Title - Sujet Roof Restoration	
Solicitation No. - N° de l'invitation EZ899-170597/A	Amendment No. - N° modif. 001
Client Reference No. - N° de référence du client	Date 2016-07-22
GETS Reference No. - N° de référence de SEAG PW-\$PWY-026-7822	
File No. - N° de dossier PWY-6-39065 (026)	CCC No./N° CCC - FMS No./N° VME
Solicitation Closes - L'invitation prend fin at - à 02:00 PM on - le 2016-08-03	
F.O.B. - F.A.B. Plant-Usine: <input type="checkbox"/> Destination: <input checked="" type="checkbox"/> Other-Autre: <input type="checkbox"/>	
Address Enquiries to: - Adresser toutes questions à: Yi (PWY), Patty	Buyer Id - Id de l'acheteur pwy026
Telephone No. - N° de téléphone (778) 919-2578 ()	FAX No. - N° de FAX (604) 775-6633
Destination - of Goods, Services, and Construction: Destination - des biens, services et construction: CBSA - Osoyoos Border Crossing - Osoyoos, BC

Project Name: Osoyoos CBSA Border
Crossing – Roof Restoration

Addendum #1

Project No. R.075896.0001

LOWER ROOF PLAN

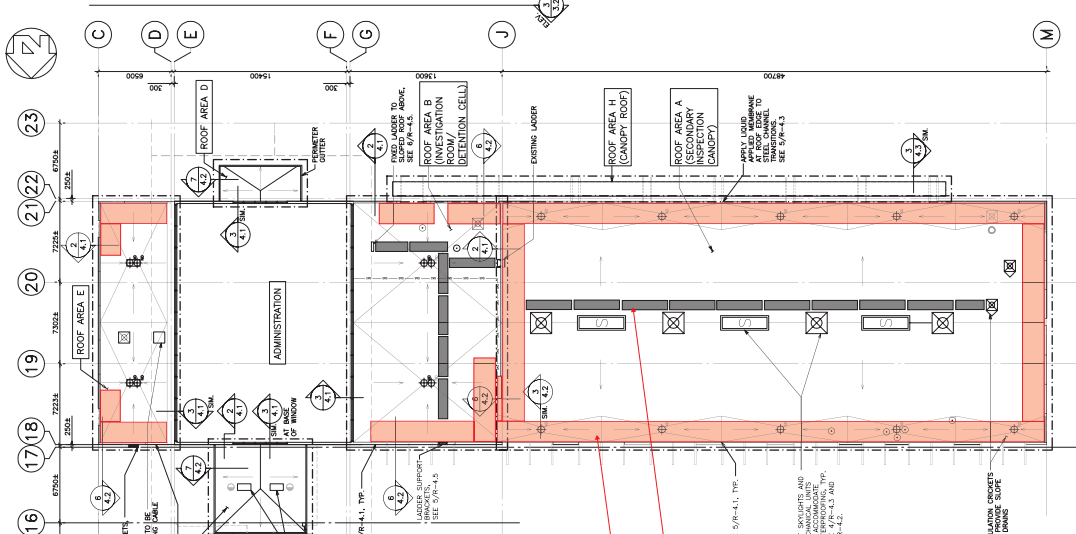
Question 8: Section 075200 Products 2.9.1 and .2 there is no indication on roof plan where these walkways and perimeter strips are to be installed. Also if a perimeter strip is used can the change of color be incorporated into the field membrane or does a second layer need to be installed on top of the field membrane.

Drawing R-2.1 - Lower
Roof Plan

Add approximate perimeter warning strip and traffic walkways layout.

Clarification 8: Refer to revised Detail R-2.1 showing the general layout of the traffic walkways and perimeter warning strip. The perimeter strip may be incorporated into the field membrane in the location of the membrane seams. The perimeter strip install orthogonal to the membrane seams shall be an additional layer.

UPPER ROOF PLAN
1:200

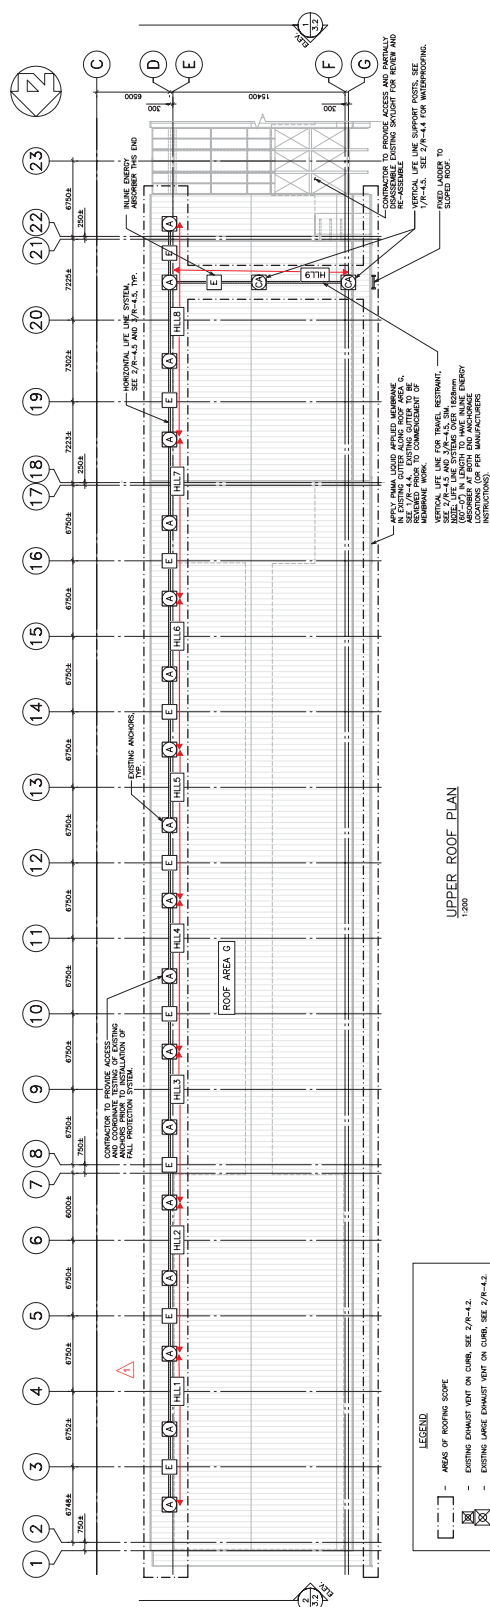
Question 2: It is not clear at which anchor any of the horizontal lifelines begin or end. It is noted that depending on their length they may require more than one energy absorber making it necessary to know where they are expected to begin and end. It would also be beneficial to know what the existing anchors are (what brand, d-ring configuration) this information should be available on the existing engineered drawings required for permanent anchors. What is the plan, or course of action for any anchors that fail testing?

Drawing R-2.2 – Upper
Roof Plan

Clarify beginning and end location of each Horizontal Life Line.

Clarification 2: Please refer to the clarifications outlined in Detail R-2.2, showing the beginning and end of the horizontal life lines (HLL). Generally, each life line includes 3 anchors and contains one energy absorber, except for HLL8 that has two energy absorbers due to the span. Existing anchor drawings and detailed information about the anchors is not available. If the existing anchor testing fails, additional scope of work will be discussed at that time.
